Sheet: /		
File: photodiode-readout.revG.kicad_sch		
Title: photodiode-readout (avalanche/MPPC/SiPM)		
Size: A4	Date: 2022-10-10	Rev: G
KiCad E.D.A. eeschema (6.0.8)		Id: 1/1

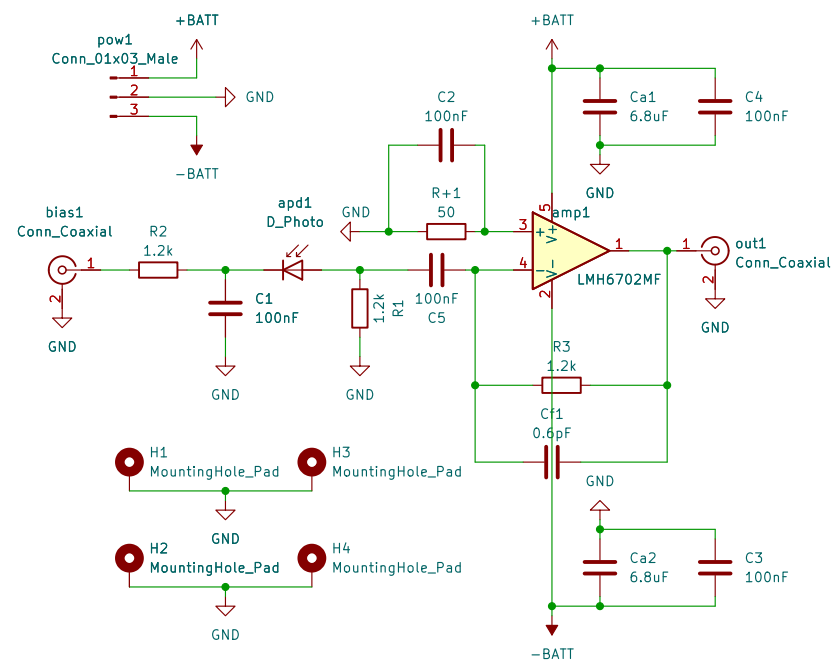
next rev should have C1 be 220pF 1kV
there should be silkscreen for +HV and OUT on the bottom of the board
put QR code on both sides
